Exhibit A

EXHIBIT A DISCUSSION

Figure 1. Sheet A13, Section.

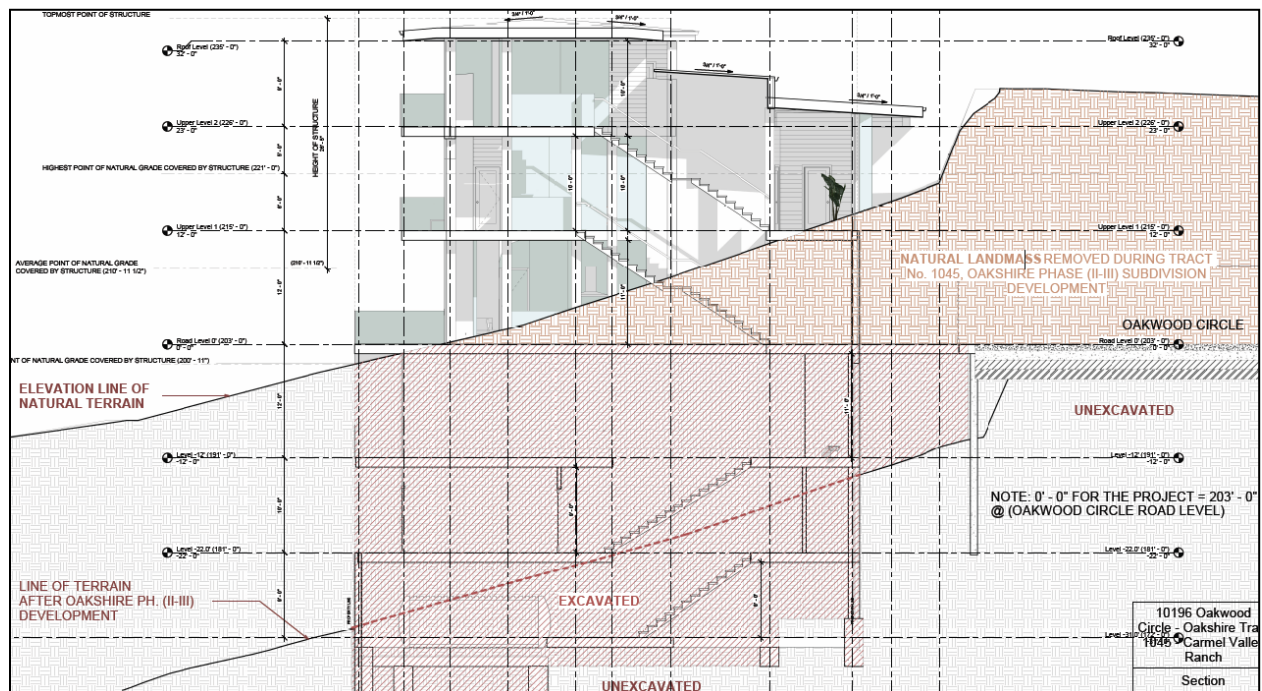
Sheet A13 of the attached project plans (**Exhibit B1**) illustrates two terrain lines (see Figure 1). The Applicant/Owner asserts that a previous natural landmass was removed after the Oakshire subdivision was approved and such grade should be considered when determining average natural grade. This "prior" grade is labeled as "Elevation Line of Natural Terrain" on Sheet A13. Below this terrain line, is another grade labeled as "Line of Terrain after Oakshire Ph. (II-III) Development". As demonstrated throughout the attached plans (**Exhibit B1**), the project plans assume that the "Line of Terrain after Oakshire Ph. (II-III) Development" represents current conditions.

To confirm which terrain line represents current conditions, HCD-Planning staff contacted the project surveyor (Monterey Bay Engineers, Inc) and consulted United States Geological Survey (USGS) maps. The project surveyor confirmed that the elevations shown on Sheet A14 (Topographic Survey) of the attached project plans (**Exhibit B1**) accurately depict the existing elevations of the property and surrounding area. The elevations depicted on Sheet A14 correspond with elevation data provided on USGS maps. Based on the topographic survey and USGS information, the portion of Oakwood Circle Road that abuts the subject property has elevations above mean sea level (AMSL) of 230 feet to 227 feet. The subject property, which steeply drops off from Oakwood Circle Road, has elevations of approximately 221 feet to 199 feet AMSL. The current topographical conditions generally correspond with the illustrated "Elevation Line of

Natural Terrain”. Contrary to this information, the Applicant/Owner has designed the project based on an erroneous supposition that the existing road and site conditions are approximately 27 feet below current conditions – claiming elevation of 203 feet AMSL for the road and 174 feet to 194 feet AMSL for the subject property. These incorrect elevations are depicted as the “Line of Terrain After Oakshire Ph. (II-III) Development”. HCD-Planning staff informed the Applicant/Owner of this error, but no revised plans have been provided as of date. By utilizing a grade condition that does not exist, the project plans and related technical reports dramatically underestimate the required ground disturbance and related site alterations necessary to support the project, as well as the resulting environmental impacts. Additionally, the grading required to accommodate the proposed residence would impact the functionality of Oakwood Circe, create a public health hazard, and be in conflict with the property’s sanitary sewer easement. These project issues are detailed below.

Figure 2. Project data sheet and corresponding floor plan.

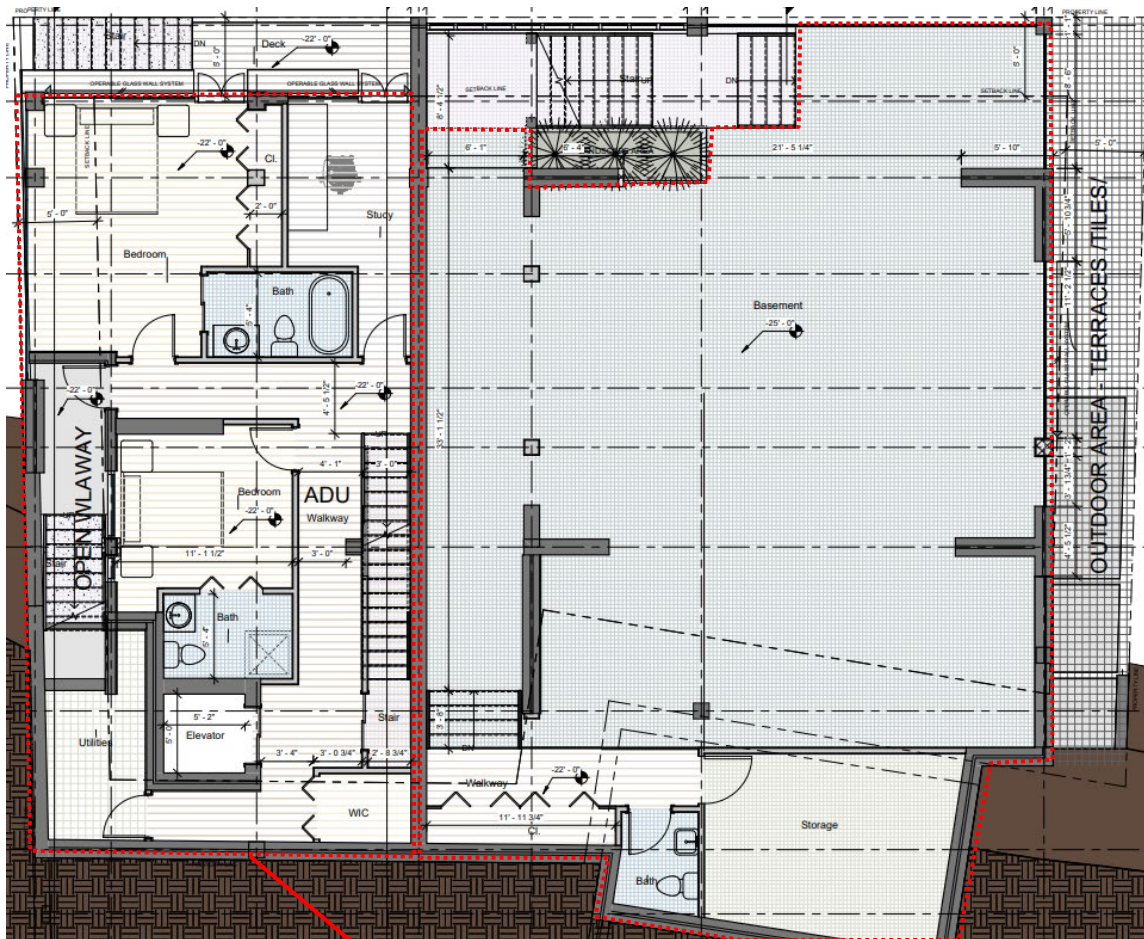
Monterey County Code requires that the square footage of each floor must be “...measured from the exterior face of the enclosing walls”. The Project Data table on Sheet A0 identifies the square footage of the residential structure’s five levels (Levels 3, 2, 1, -1, and -2). However, as illustrated in the detailed floor plans and elevations (see Sheet A12), the proposed residential structure contains six levels. Therefore, the square footage total listed on Sheet A0 is unrepresentative of the proposed project’s total size. Additionally, staff has concerns that the provided square footages are not calculated correctly. For example, the proposed basement shown on Sheet A6 is listed at 385 square feet, however, the adjacent lower level of the proposed ADU, also shown on Sheet A6 and visibly smaller than the basement area, is listed at 800 square feet (see Figure 2). Thus, in addition to the Applicant/Owner electing not to provide the sixth (lowest) floor’s square footage, the provided square footage appears to be calculated incorrectly. HCD-Planning staff requested that the project plans be updated with the correct square footage information, however, the Applicant/Owner has yet to comply with this request.

Based on the Project Data table (see Sheet A0 of **Exhibit B1**), the project consists of a 7,112 square foot six-story single-family dwelling (inclusive of stairs, entry, and elevator) with an attached 832 square foot garage, an attached 1,600 square foot ADU, an attached 483 square foot JADU, and 2,347 square feet of covered and uncovered decks, for a total square footage of 12,374 square feet. Given the apparent inconsistencies of Sheet A6, staff manually calculated the floor area for the entire structure using the provided ¼ inch to 1-foot scale. Per staff’s rough calculations, the project consists of a 12,469.5 square foot six-story single-family dwelling with an attached 934 square foot garage, an attached 2,124 square foot ADU, an attached 483 square foot JADU, and 3,419.5 square feet of covered and uncovered decks, patios, and exterior staircases, for a total square footage of 19,430 square feet. Staff’s calculations indicate that the residential structure is approximately 7,056 square feet larger than the Applicant’s calculations. Since the project site is part of a planned unit development (PUD), it is not subject to floor area ratio (FAR) or lot coverage limitations. Consequently, the total floor area of the project is not required to determine consistency with FAR requirements. However, providing accurate information is required for consideration of the project and the project’s total square footage contributes to its bulk and mass, which is discussed below.
